**Re: Noon Day
2500 Second St NW
Request Permanent C.O. - Accepted
Engineer's Stamp dated: 12-5-13 (H14D067)
Certification dated: 11-26-14**

**RE: Grading and Drainage Plan
Noon Day (H14-D067D)**

RE: **Noon Day, 2500 2nd St**
Grading and Drainage Plan
Engineers Stamp Date 12/05/13 (H14-D067)
Engineer's Certification Date 11/4/2014

Re: Noon Day 2500 2nd St NW
Grading and Drainage Plan
Engineer's Stamp Date 10/31/13 (H14/D067)

North Culvert
↓

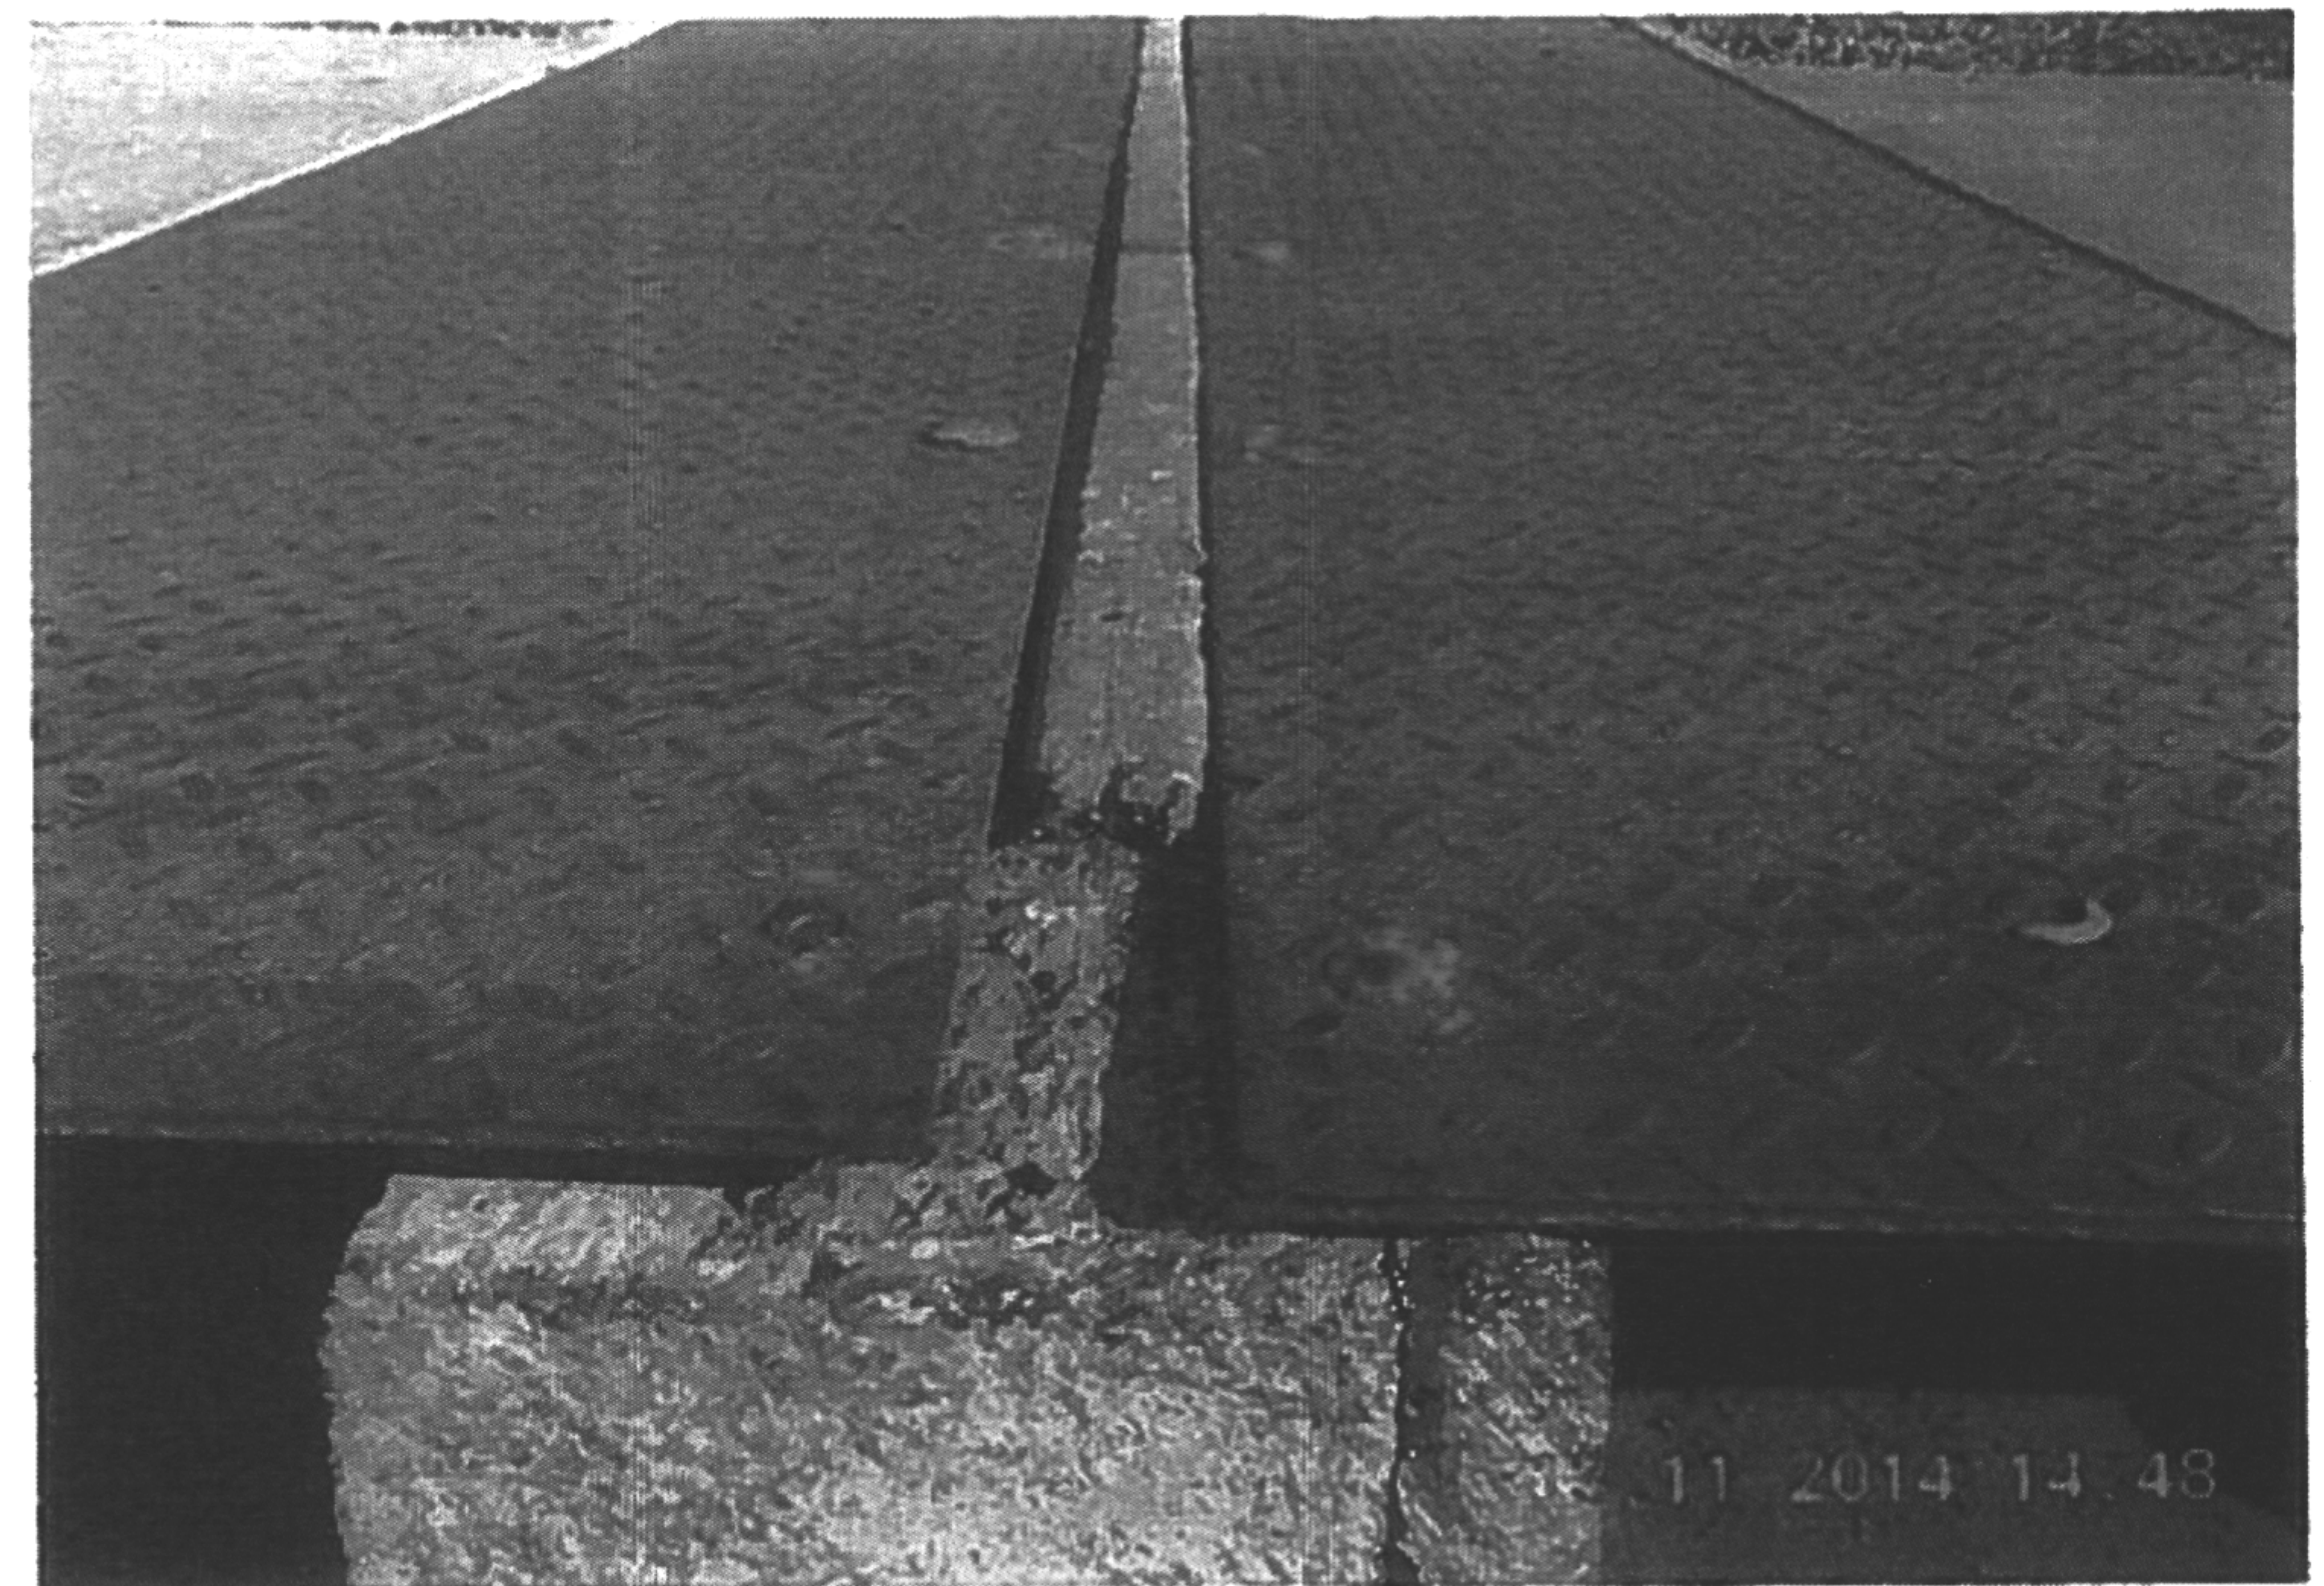
North culvert plates 2 feet with 17 inch openings plan calls for two 24 inch. Plate is welded but there is no expansion on both ends the plate is painted no other deficiencies

South culvert is a no pass cracked center with missing concrete at face tripping hazard. Cracked north side curb at cold joint through back of curb, epoxy over bolts. And no bar on street end of plate, openings are 17 inches. Recommendation is to remove south culvert saw cut at cold joint ramp end. North to give room to have the 6 inch space to expansion at both ends
